PI00000170-US

Product Range: ICC Size 20 Series

Title: ICC Size 20 Product Improvement

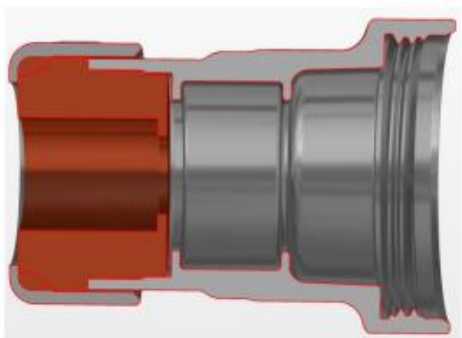
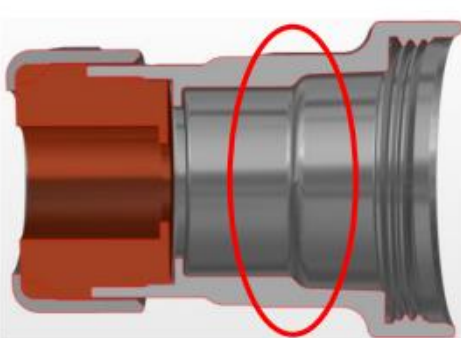
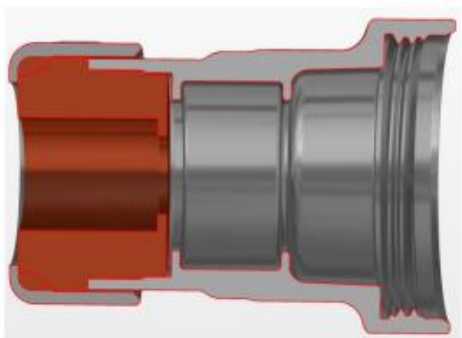
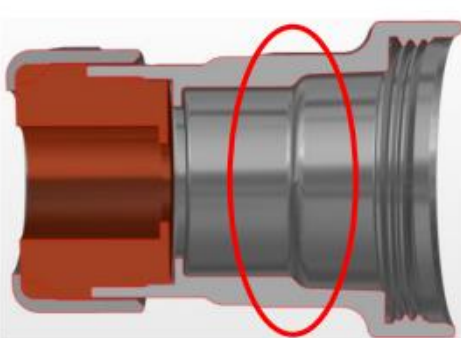
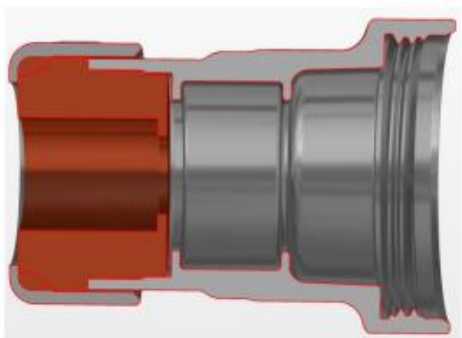
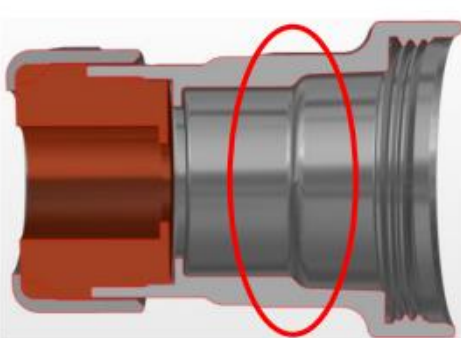
1. Concerned Part Numbers				
19591204011, 19590202801, 19591204012, 19590202802, 19591204013				
2. Description of Changes/News				
<p>We are making a change to the back shell and insert of the ICC Size 20 range to improve the use and customer experience.</p> <p>1. ICC Shell Change</p> <p>Change to the inner contour of the ICC Size 20 Backshell which has no influence on the use of the article. Here an internal contour is changed that was intended for future use as an EMC variant. As this has shown limitations in the use of large cable cross-sections without EMC, we have decided to make this change. Future EMC variants will be given their own article number.</p> <table border="1" style="width: 100%; text-align: center;"> <tr> <td data-bbox="207 1299 782 1332">Old revision</td> <td data-bbox="782 1299 1356 1332">New revision</td> </tr> <tr> <td data-bbox="207 1332 782 1747">  </td> <td data-bbox="782 1332 1356 1747">  </td> </tr> </table>	Old revision	New revision		
Old revision	New revision

2. Additional Laser Printing for Coding

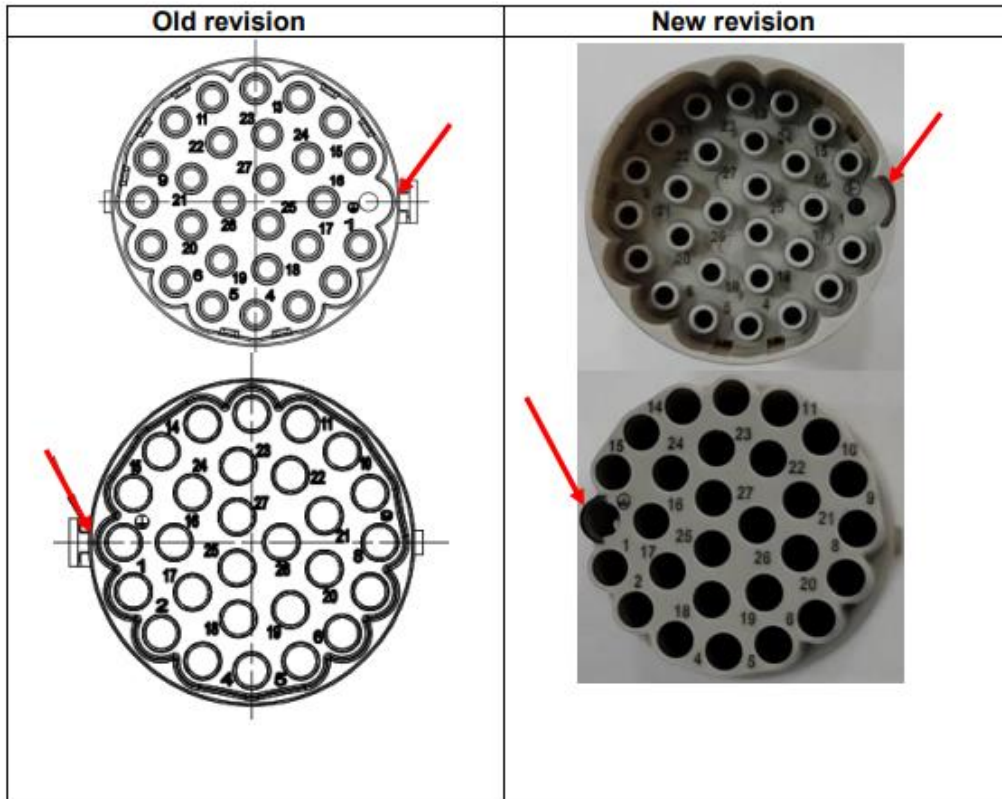
An additional laser marking on the mating side makes it easier for the customer to determine the selected coding position in the installed state. This change also has no influence on the use and only serves to optimise handling by the customer.
